**ADDENDUM NO. 6
TO
CONTRACT DOCUMENTS, SPECIFICATIONS AND PLANS
FOR IMPROVEMENTS TO THE
ST. JOSEPH ROSECRANS MEMORIAL AIRPORT
ST. JOSEPH, MISSOURI
MODOT PROJECT NO. 22-012A-1**

To All Bidders: You are requested to make all changes and/or additions contained in this addendum to the Bidding Documents. Failure to acknowledge this Addendum in Proposal shall result in rejection of bid. Bidders are informed that the above referenced Questions with Corresponding Answers, Contract Documents, Specifications, and Plans are modified as follows as of December 12th, 2022.

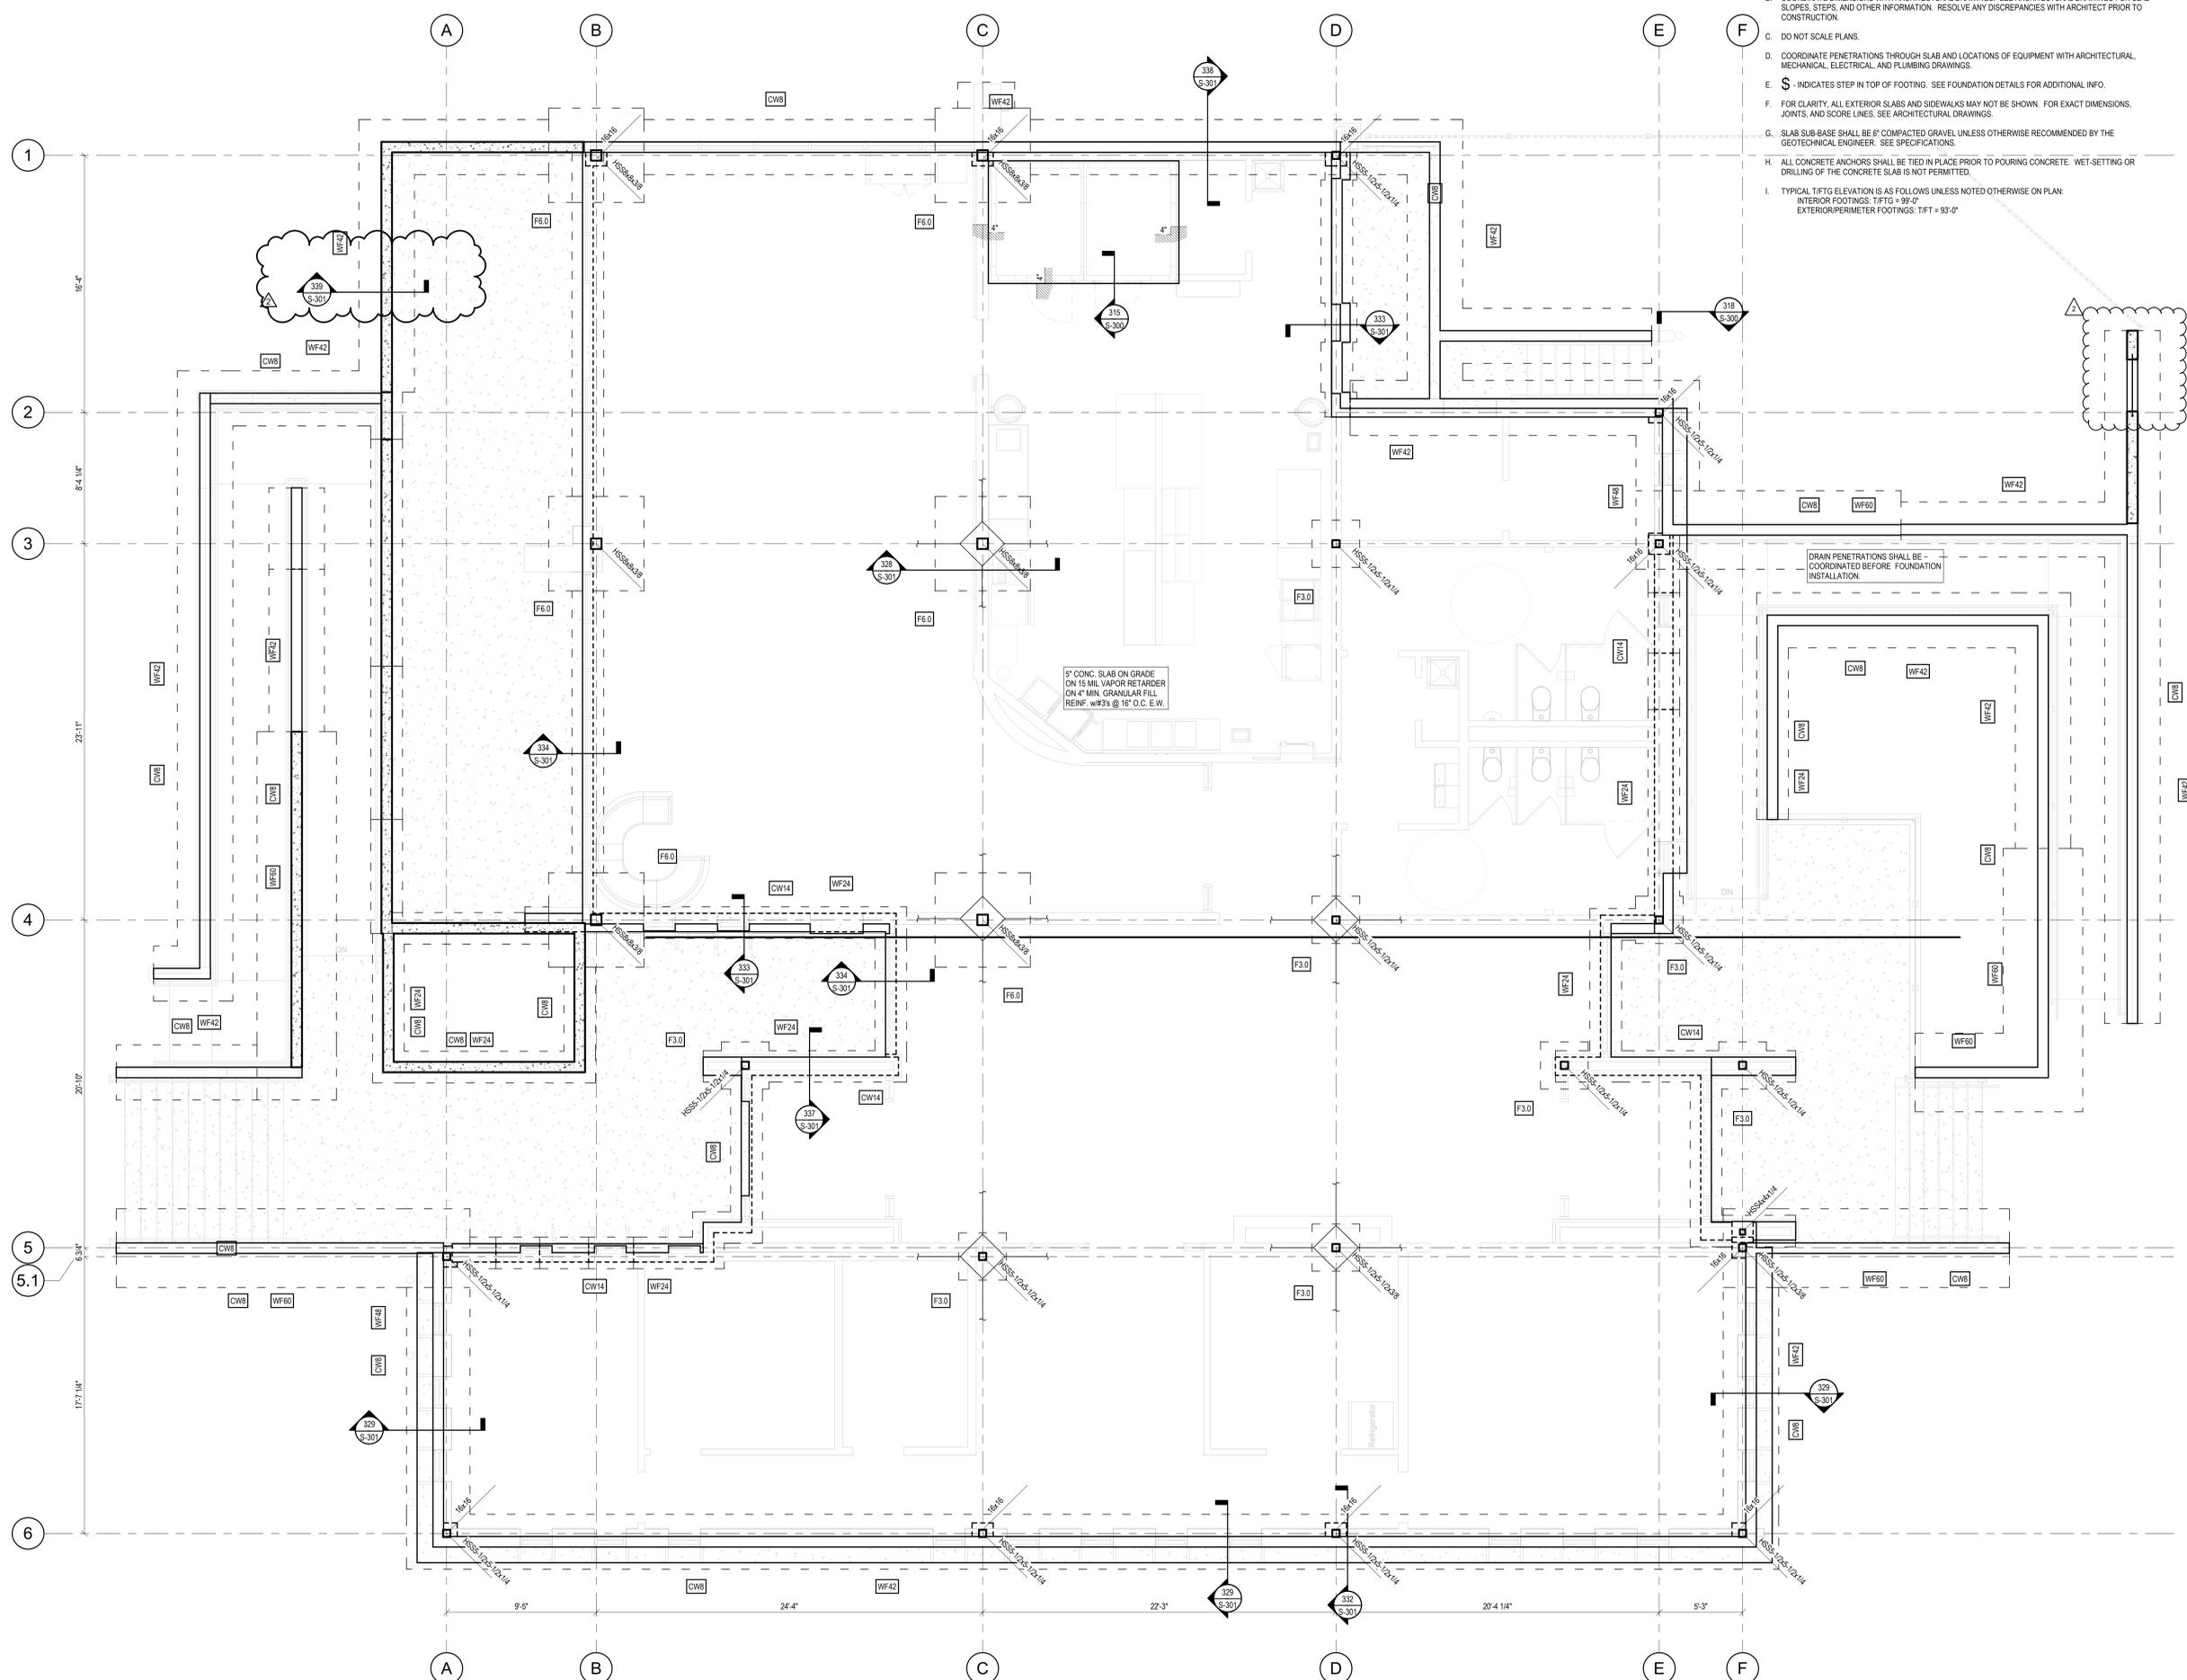
12. Is the water main on sheet C- 900 a private main or is it a Missouri American Water service line? Who is responsible for the relocation?

- a) The contractor will be responsible for all water line utility work and will include such pricing in their bid. The contractor shall subcontract with an approved Missouri Water contractor for the work, and the work shall conform to Missouri Water's standards and specifications.

FOUNDATION PLAN
1/4" = 1'-0"

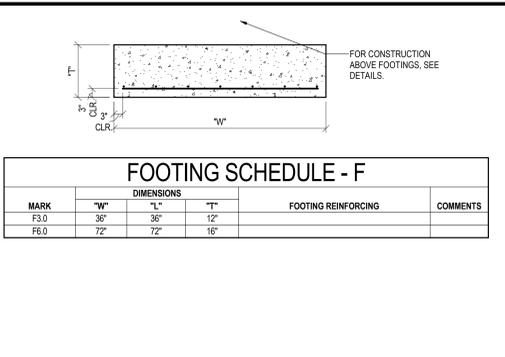
1. Plans
Sheet S-200
Revision: North East Side of Service Area Foundation Plan Updated

303 WALL SCHEDULE
1/2" = 1'-0"

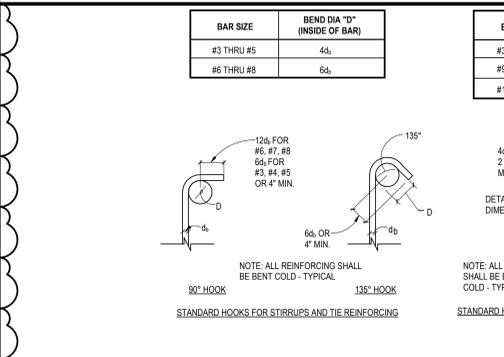
2. Plans
Sheet S-300
Revision: Detail 303 Wall Schedule Updated

A3 SCREEN HIGH WALL SECTION
SCALE: 3/4" = 1'-0"

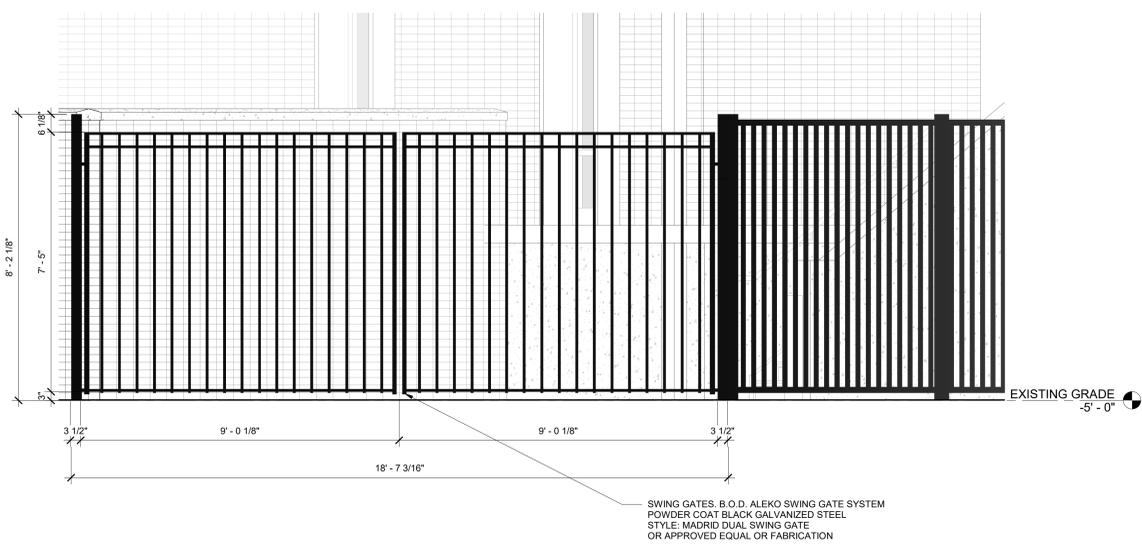
4. Plans
Sheet A-203
Revision: Detail A3 Added
